B-12 / B-14:

Question Commissioner Connolly

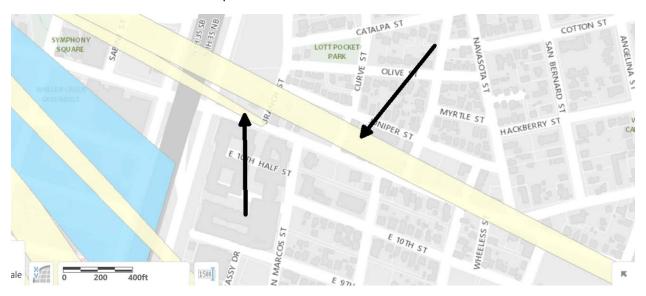
I'm reviewing items 12-14, and find it would be helpful if staff could provide us with more information about the Capitol View Corridor overlap with 11th and 12th st.

Specifically, I think it would be immensely helpful in our discussion if we could know what the height determinations are for the parcels in the Urban Renewal Plan area that fall within the CVC.

There are two CVCs that affect portions of the East 11th Street NCCD and Urban Renewal Plan (URP). The first and most prominent is the "East Seventh Street Bridge over the Texas-New Orleans Railroad" which covers the north side of East 11th Street from Branch to Navasota Streets within the boundaries of the URP. It does not affect Rosewood Avenue. The second is the "11th Street Threshold" corridor which end at Branch Street. See map below.
